### REMARKS

The Office action of February 27, 2004, has been carefully considered.

*Fig. 6*

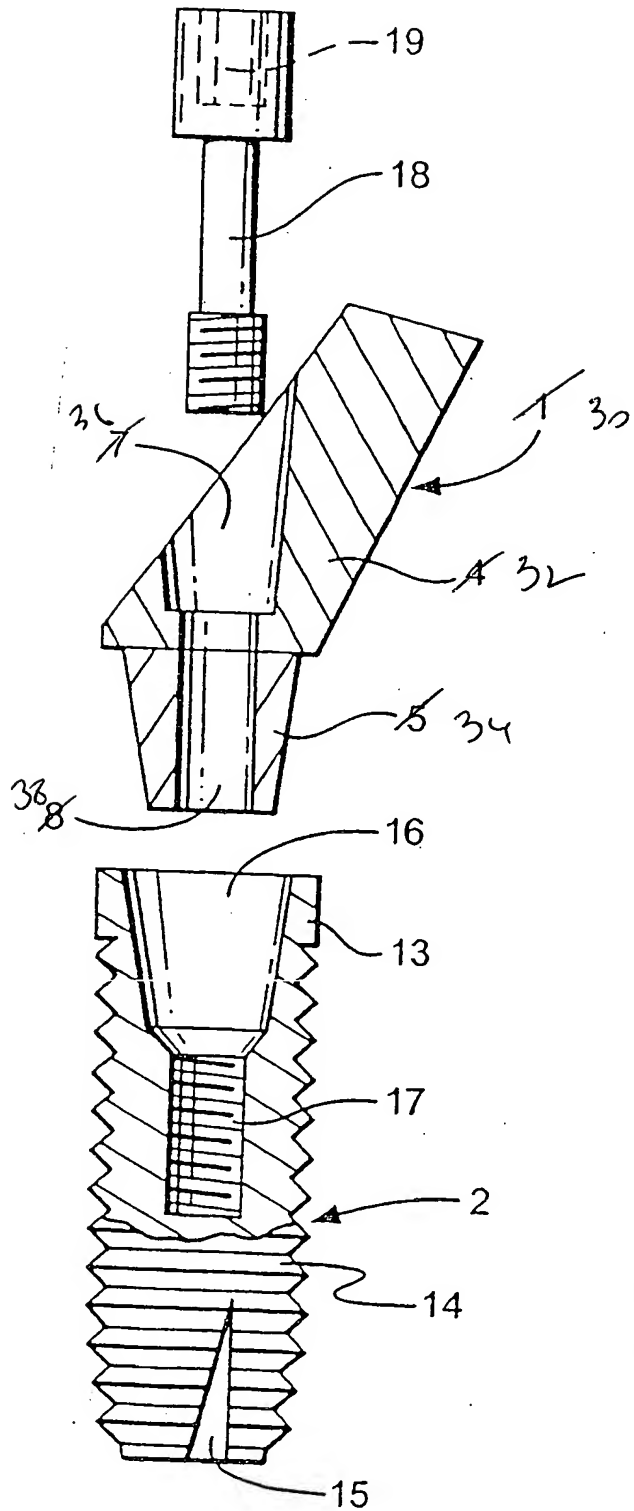
Moreover, Applicants have also noted that Figures 6 and 8 are directed to abutments rather than templates, especially given the presence of bolt 18 which locks the abutment onto the implant. Applicants have therefore renumbered Figures 6 and 8 in accordance with the abutment as shown in Figure 2, and amended the specification in accordance with this new numbering. Applicants believe that these changes do not constitute new matter because one of ordinary skill in the art would understand that Figure 6 and 8 relate to abutments rather than templates.
